CERTIFICATE OF APPROPRIATENESS

Property: Lot 25, Tract 26A, Block 204, Houston Heights Subdivision. The property includes an historic 1,413 sq. ft., one-story wood frame single-family residence and a detached garage situated on a 6,600 sq. ft. (50' x 132') interior lot.

Significance: Contributing Craftsman residence, constructed circa 1920, located in the Houston Heights Historic District West.

Proposal: Alteration – Front Porch Repair and Reconstruction

PROPOSED WEST ELEVATION

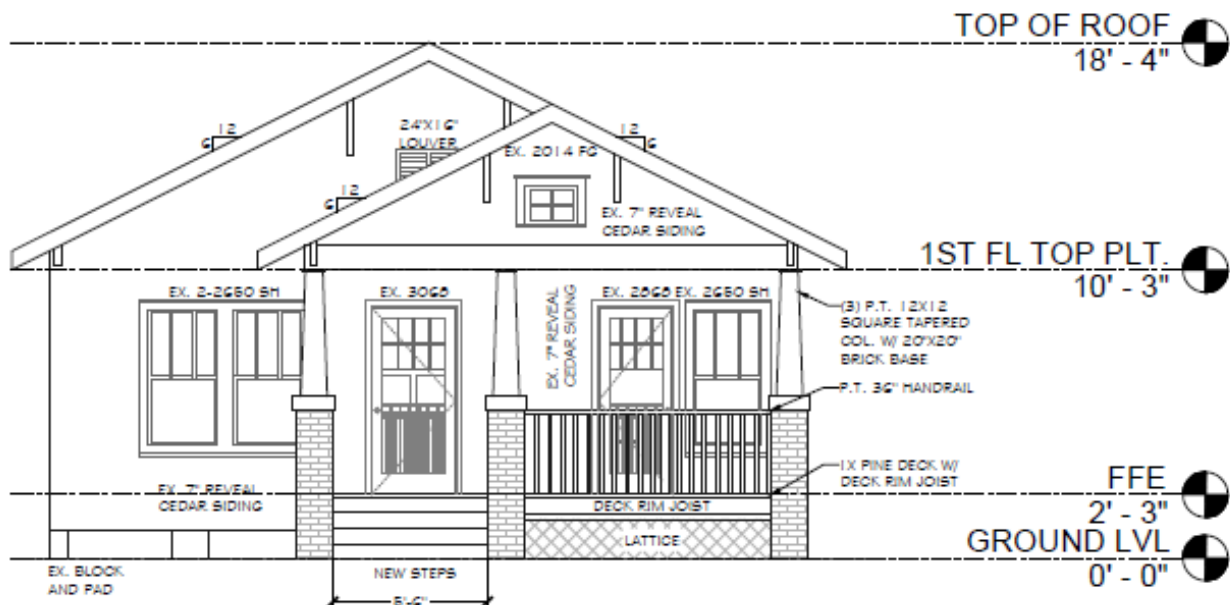
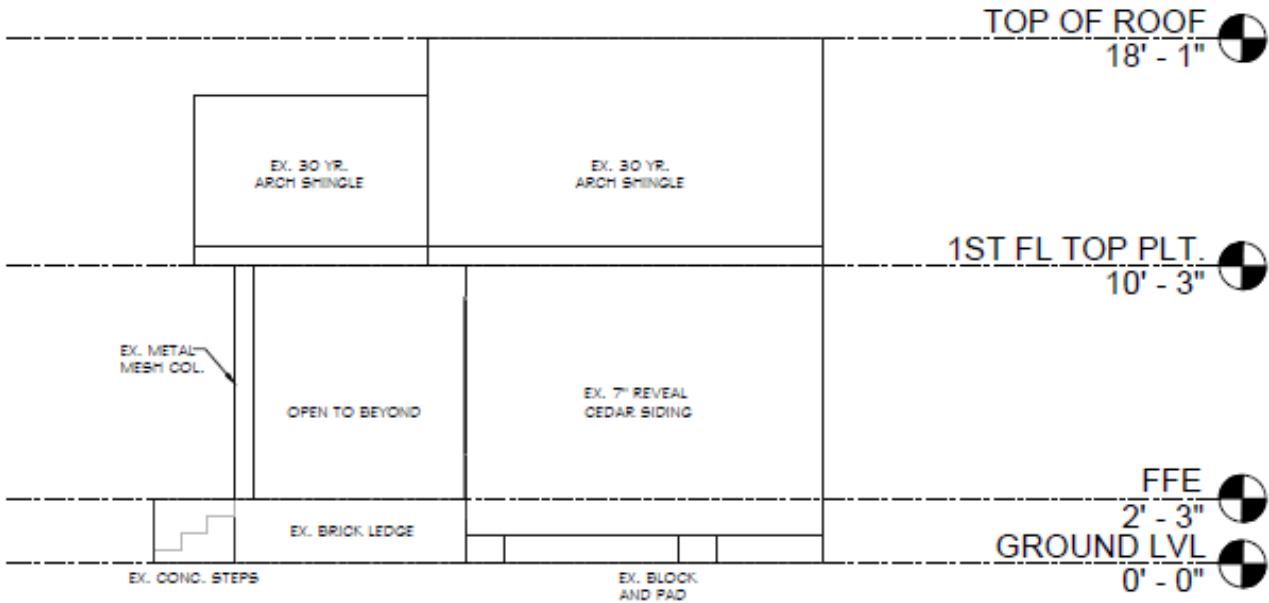
- Porch decking with tongue and groove pine, 1" x 4" (3/4" x 3 1/8" actual)
Construction of (3) period appropriate columns, with single bead at base of column and top of column (minimal ornamentation).
- Tapered square wood columns will sit on capped brick pillar bases.
- Brick steps will be framed by brick knee-wall/ risers.

S	D	NA		S - satisfies	D - does not satisfy	NA - not applicable
<input checked="" type="checkbox"/>	<input type="checkbox"/>	<input type="checkbox"/>	(1)	The proposed activity must retain and preserve the historical character of the property; <i>Proposed porch and steps are compatible with the existing home and context area.</i>		
<input checked="" type="checkbox"/>	<input type="checkbox"/>	<input type="checkbox"/>	(2)	The proposed activity must contribute to the continued availability of the property for a contemporary use;		
<input checked="" type="checkbox"/>	<input type="checkbox"/>	<input type="checkbox"/>	(3)	The proposed activity must recognize the building, structure, object or site as a product of its own time and avoid alterations that seek to create an earlier or later appearance; <i>Proposed porch and steps are compatible with the context area, while not copying porches of contributing buildings.</i>

FRONT PORCH DECKING in a Historic District must be: 1 in. x 4 in. Tongue and Groove (T&G), laid front to back. Actual lumber dimensions of 3/4 in. x 3 1/8 in.
